**DUKE POWER COMPANY**

Subject: Oconee Nuclear Station  
Docket Nos. 50-269, -270, -287  
NUREG Item II.F.1.4 Containment Pressure Monitor  
II.F.1.5 Containment Water Level Monitor  
II.F.1.6 Containment Hydrogen Monitor

Response to Request for Additional  
Information on NUREG-0737 Items

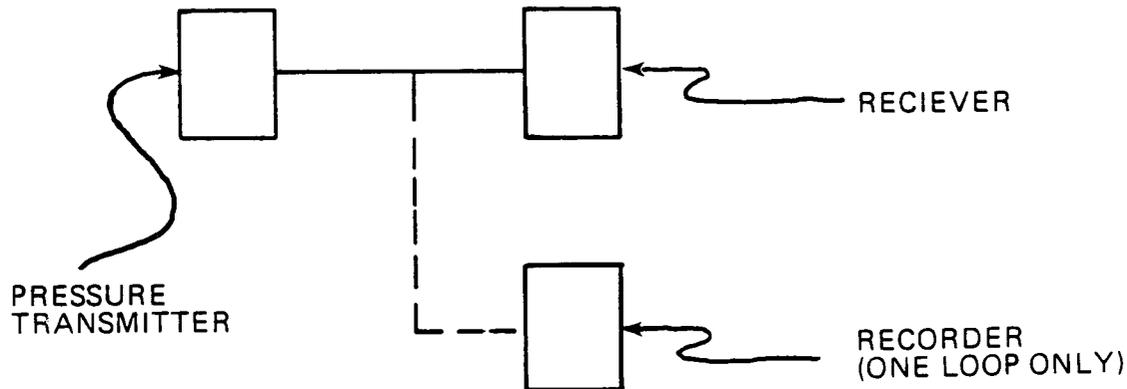
Request: (2a) Provide a block diagram of the configuration of modules that make up your PMS. Provide an explanation of any details in the block diagram that might be necessary for an understanding of your PMS accuracy and time response.

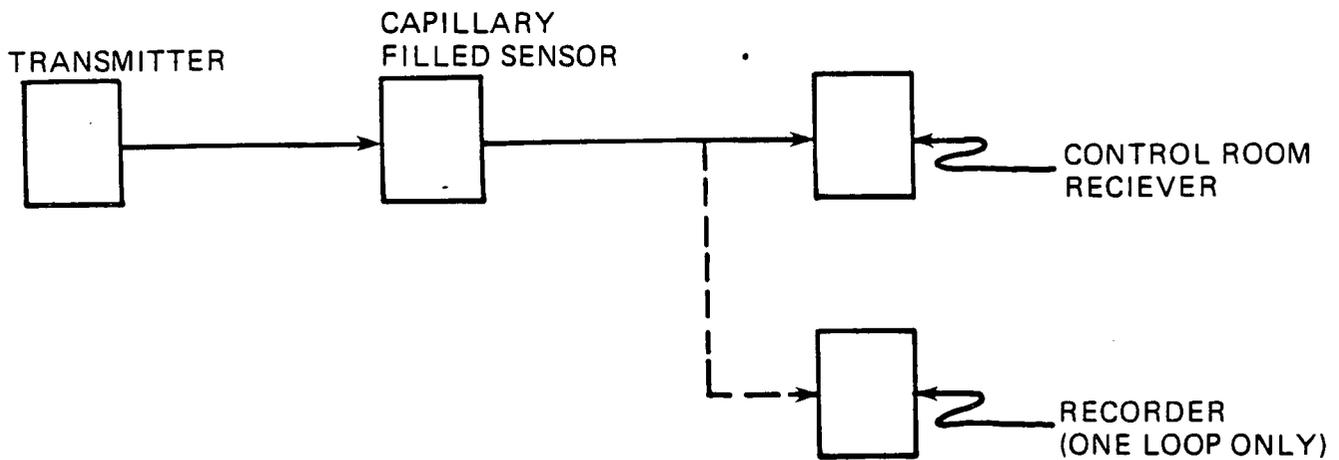
Request: (3a) Provide a block diagram of the configuration of modules that make up your WLMS. Provide an explanation of any details in the block diagram that might be necessary for an understanding of your WLMS accuracy.

WIDE RANGE SYSTEM

NARROW RANGE SYSTEM

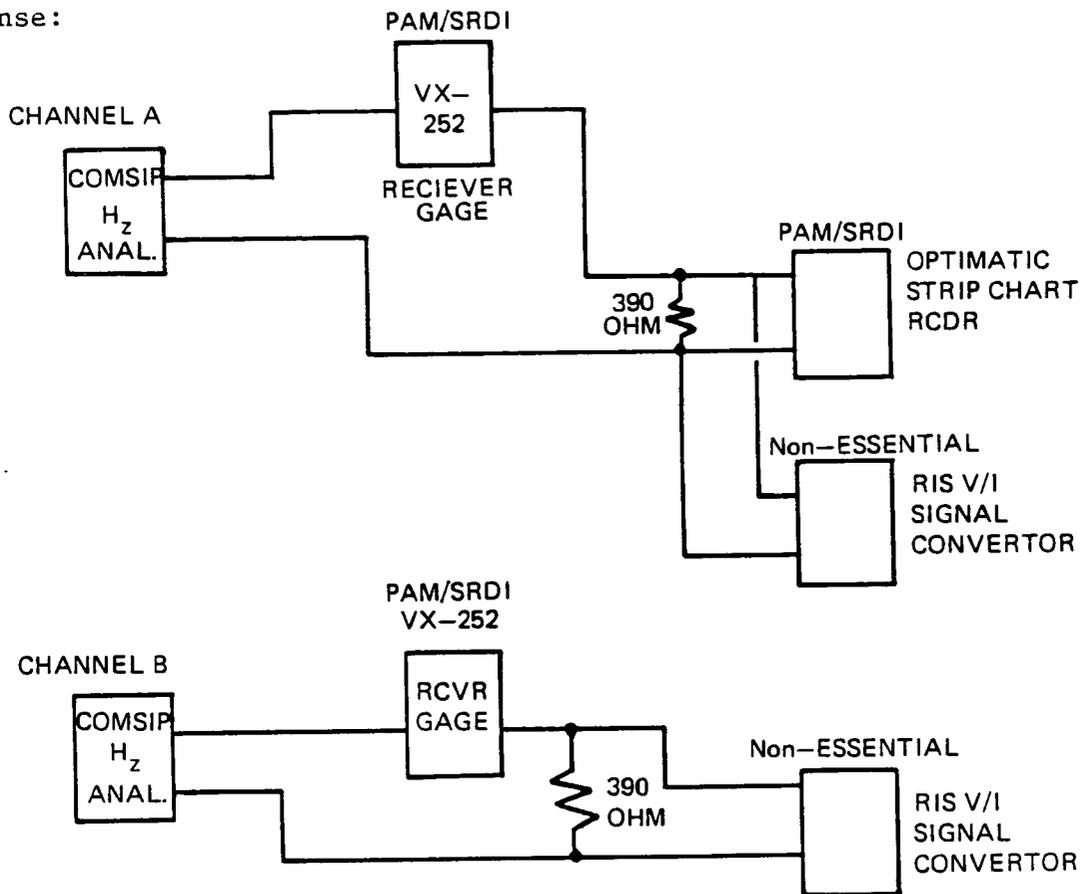
Request: (4a) Provide a block diagram of the configuration of modules that make up your HMS. Provide an explanation of any details in the block diagram that might be necessary for an understanding of your HMS accuracy. If you have different types of HMS give this information for each type.
